### HIGHLAND CITY PLANNING COMMISSION Tuesday, November 10, 2015 – Regular Meeting 7:00 p.m.

**REQUEST:** Preliminary Plat approval for Blackstone a-86 unit townhome subdivision.

# BLACKSTONE TOWN HOMES PUD

SHEET  
**2 OF 2**

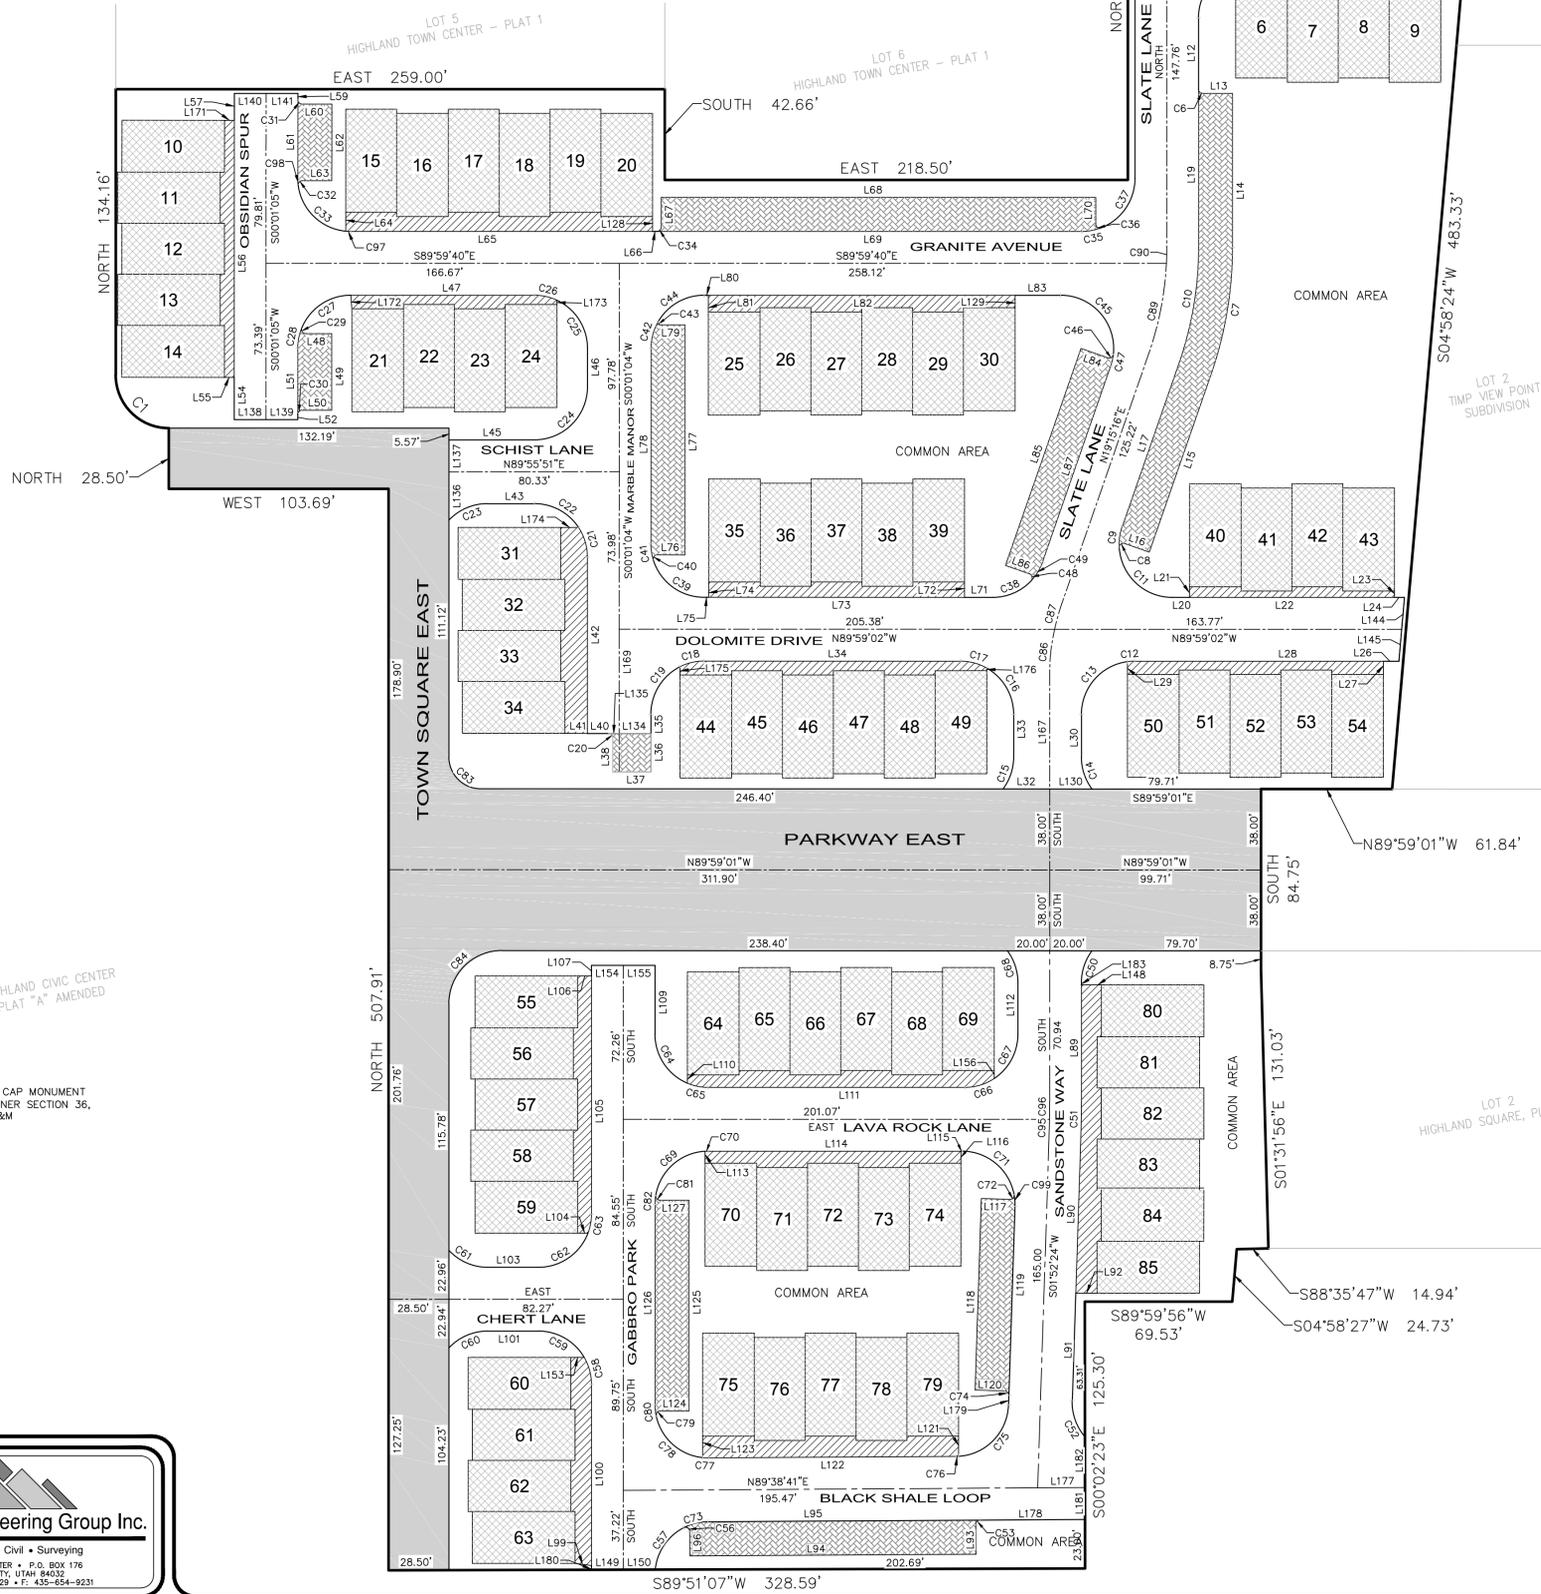
- Public water, sewer, and storm drain lines are proposed in the private roads. The City Engineer and Public Works Department will need to approve the location of all utilities prior to final plat approval. In addition, an easement to allow access to these lines will need to be included.

- The location of water, sewer, and pressurized irrigation lines in relation to lot lines and building foundations will need to be reviewed with the civil improvement plans to ensure adequate spacing.

1. The final plat shall be in substantial conformance with the preliminary plat date stamped November 5, 2015.
2. Final landscape plans shall be approved prior to recording the final plat. The landscape plans shall be revised to show compliance with the Parkway East design standards located on page 17-22, and 30 of the Town Center Design Standards and Section 3-4729.8 and Section 3-4731.a.7.

**Landscape Plan**  
 Scale: 1" = 60'-0"

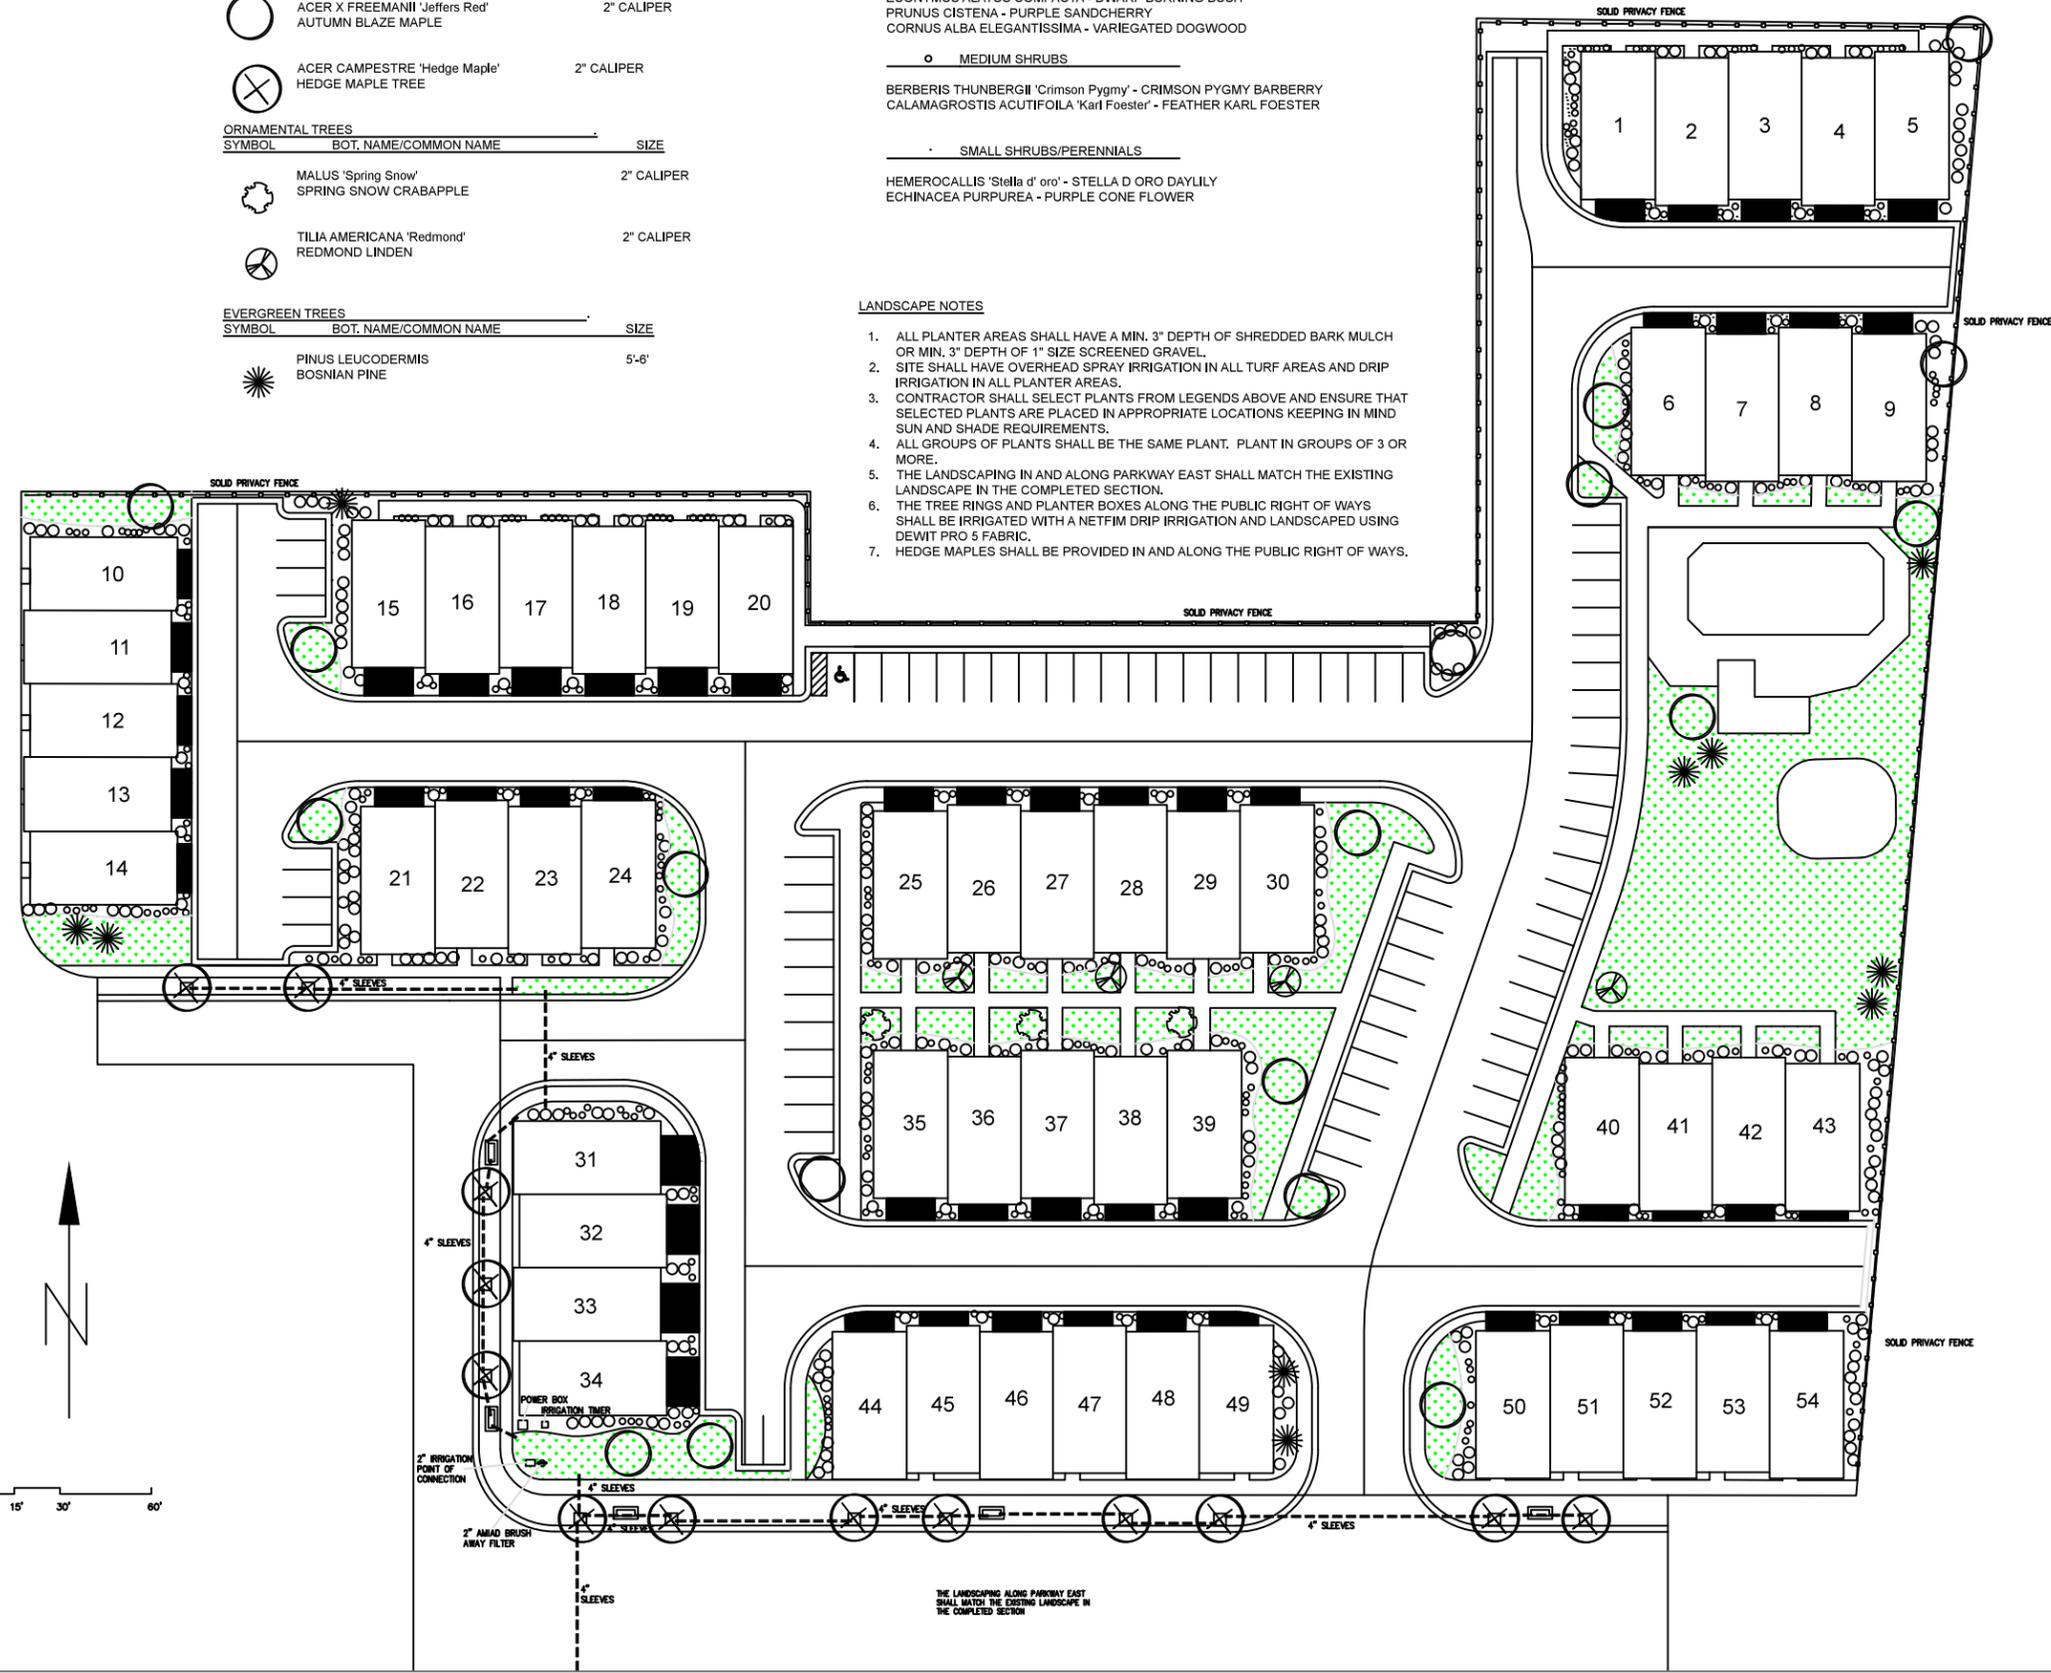
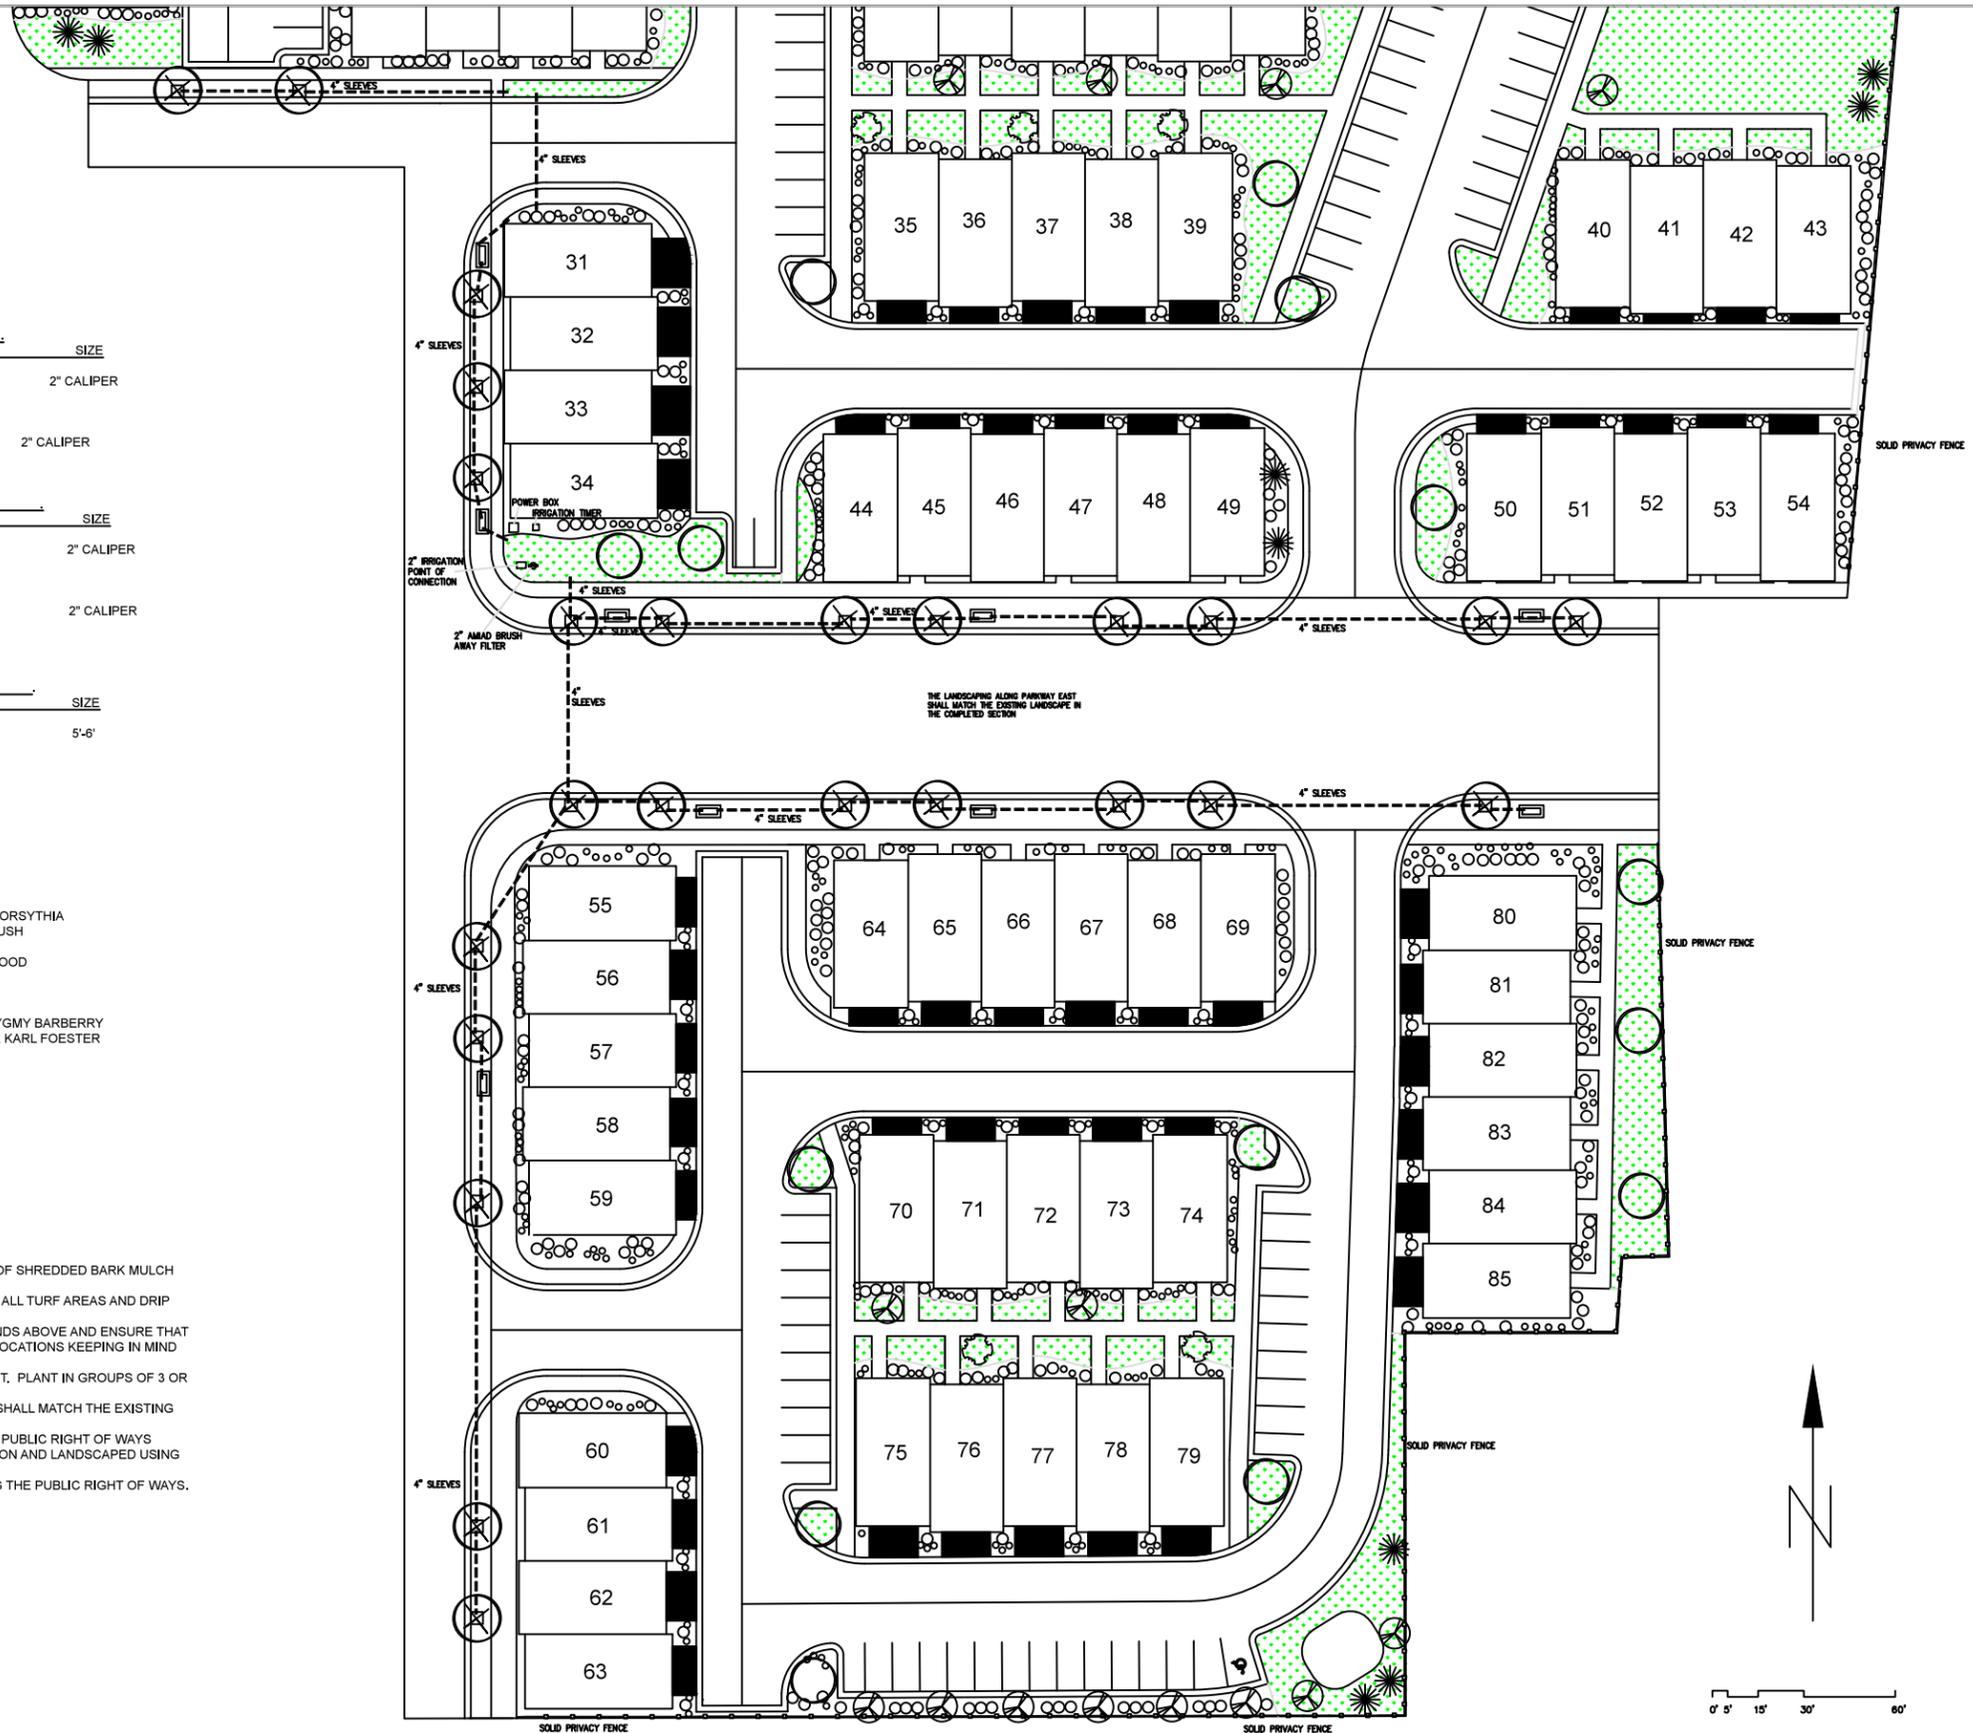
landscape area. Rather they are included in Section 3-4731 Hardscape. Some of the landscape area has been removed due to the addition of parking stalls. If the sidewalks are removed, then the site will be short the minimum 15% (Attachment 5).

*Analysis: A note on the landscape plan has been provided for a solid privacy fence. However no detail has been provided. A stipulation has been included to address this issue.*

*Analysis: Unable to verify due to scale issues on landscape plan. Stipulation included with the preliminary plat.*

13. A minimum 15% of landscaped area shall be included. These areas shall meet the requirements of Section 3-4729 of the Highland City Development Code.
